ENGINE - LP COMPRESSOR - ADD PART NUMBER MARKINGS TO VARIOUS ADJUSTING WASHERS -
CATEGORY CODE 6 - MOD.ENG-72-0114

V2500-ENG-72-0114

Location of the HPC and the PTO adjusting washers
Fig.1

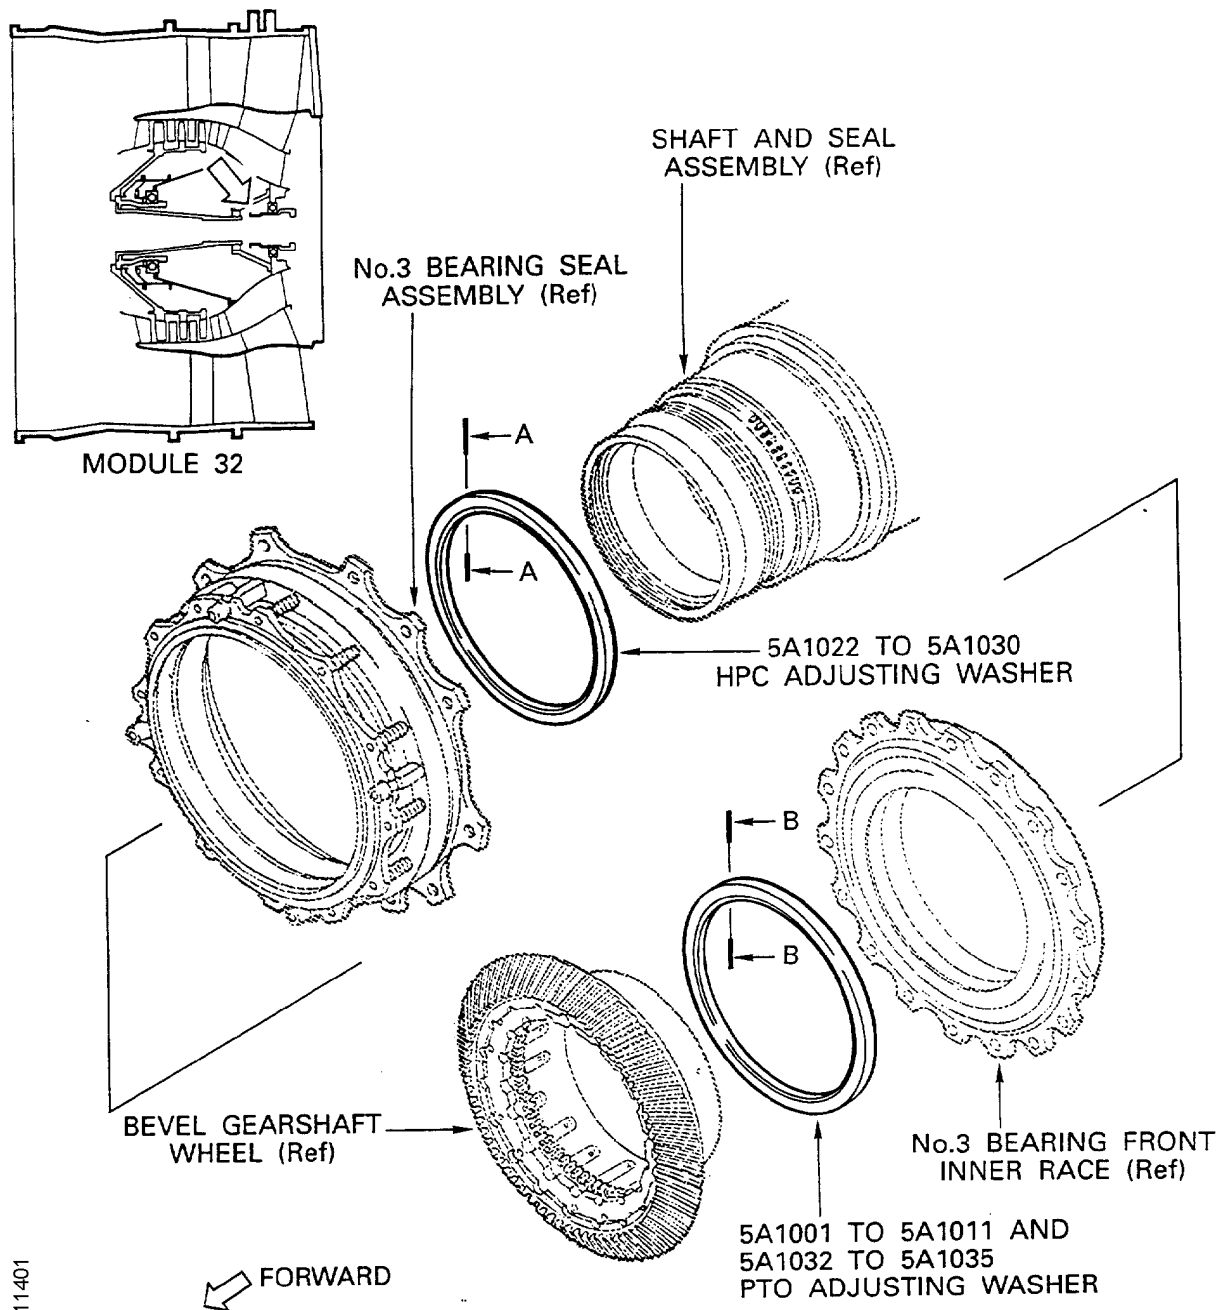
- (1) Make a mark of the part number on to the existing HPC adjusting washers as follows (Refer to Figure 1 and 2);

- (b) Identify the part number of the HPC adjusting washer which is installed between shaft & seal assembly and No.3 bearing seal assembly

- (b) Identify the part number of PTO adjusting washer which is installed between the bevel gearshaft wheel and No.3 bearing front inner race.

Marking position of the HPC and the PT0 adjusting washer
Fig.2

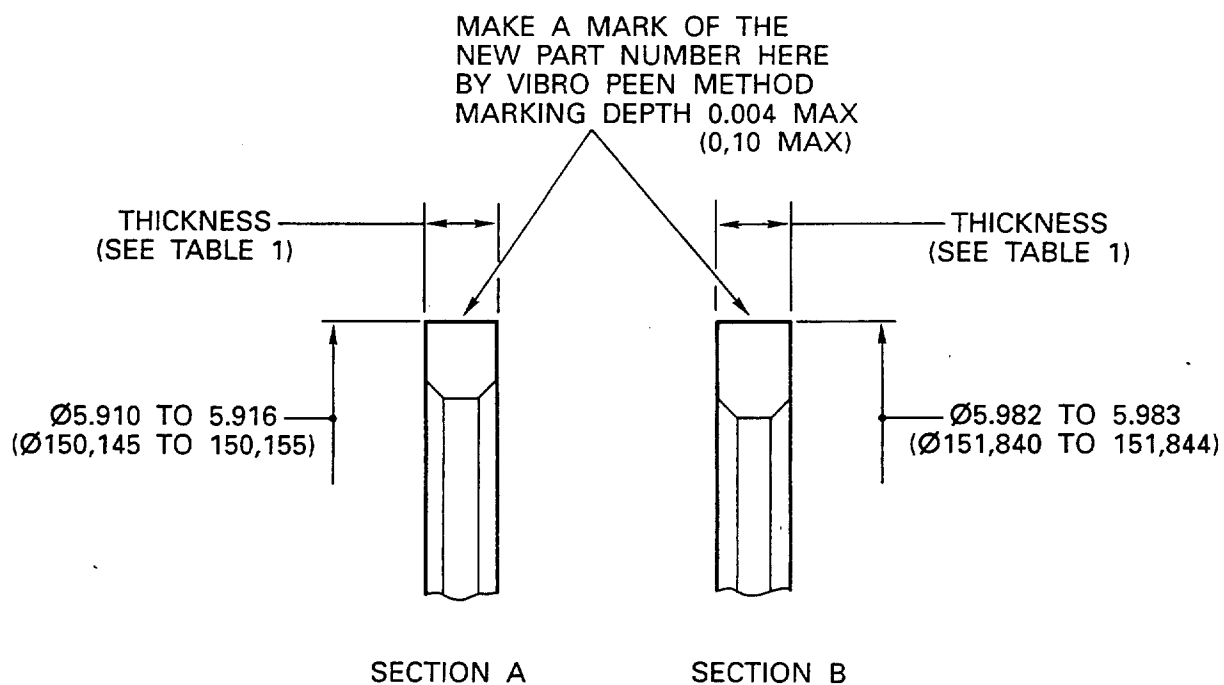
- (c) Make a mark of the part number on to the HPC adjusting washer. Use the vibro-peen method by approved procedures in Reference (3), Chapter/Section 70-09-00, Marking of Parts.

- (c) Make a mark of the part number on to the PTO adjusting washer. Use the vibro-peen method by approved procedures in Reference (3), Chapter/Section 70-09-00, Marking of Parts.
